## Commission of Architectural Review

1. COA-129910-2023	<b>Final Review</b>	Meeting Date: 5/23/2023
Applicant/Petitioner	Brandi Battle-Brown	
Project Description	Install a mural on a previously painted masonry wall of a mixed-use building.	
Project Location		
Address: 23 W Marshall Street		
Historic District: Jackson Ward		
High-Level Details: Applicant proposes to install a mural on previously painted brick wall of a mixed-use building.		
Staff Recommendation	Approval, with Conditions	
Staff Contact	Samantha Lewis, <a href="mailto:Samantha.lewis@rva.gov">Samantha.lewis@rva.gov</a> , 804-646-5207	
Previous Reviews	None.	
Conditions for Approval	<ul style="list-style-type: none"> <li>Installation of the new mural is to stay within the boundaries of the previously painted brick.</li> </ul>

Figure 2. Elevation on North Adams

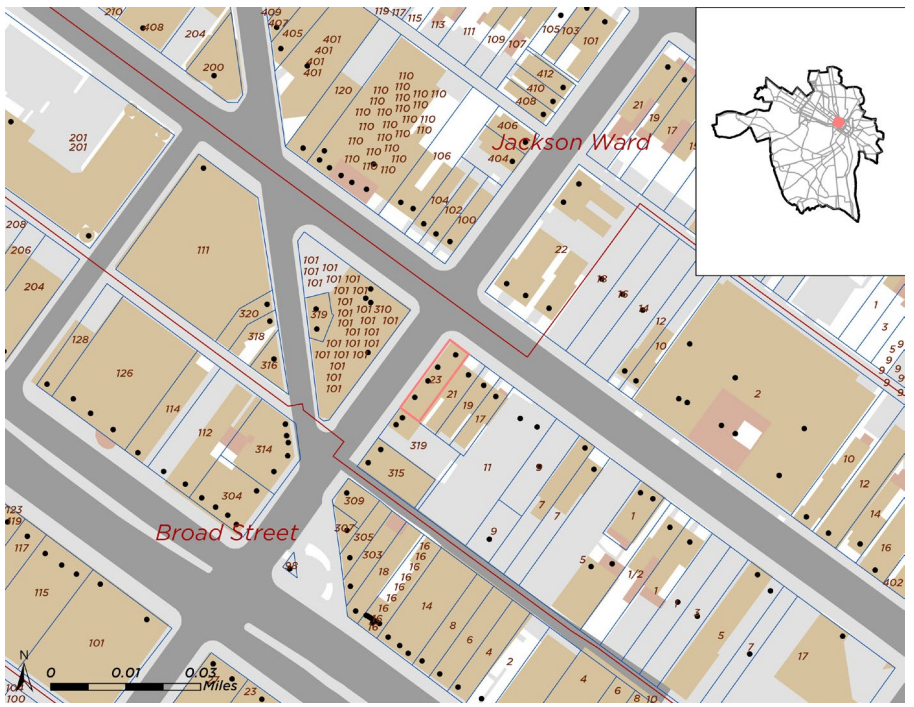
<b>Standards for Signage, p. 75, #1</b>	<i>Adding a mural to a previously-painted, non-primary elevation of a contributing building will be considered on a case-by-case basis.</i>	The building is not considered contributing to the Jackson Ward Historic District. The building features a shaped parapet façade wall, a large center window that features 4/4 and 8/8 center window with matching transoms above. Above the center window is a brick arch with a keystone ornamentation with a center diamond made of brick. The bottom half of the building features a traditional storefront that wraps the corner and red painted brick. The mural will be located along North Adams Street on the already painted brick.
<b>Standards for Signage, p. 75, #2</b>	<i>Murals painted on primary facades are not permitted.</i>	The proposed mural will be painted on a secondary façade, the elevation facing North Adams Street.

<b>Standards for Signage, p. 65, #4</b>	<i>A mural should not obscure or distort the historic features of a building.</i>	Staff notes there are no defining features on the elevation facing North Adams.
<b>Standards for Signage, p. 75, #5.</b>	<i>Murals should be in compliance with the general signage requirements for Old and Historic Districts, where applicable.</i>	Staff notes that this mural is not considered a sign by the underlying zoning. <u>Staff recommends approval of the mural with the condition the new mural stays within the boundaries of the previously painted brick.</u>
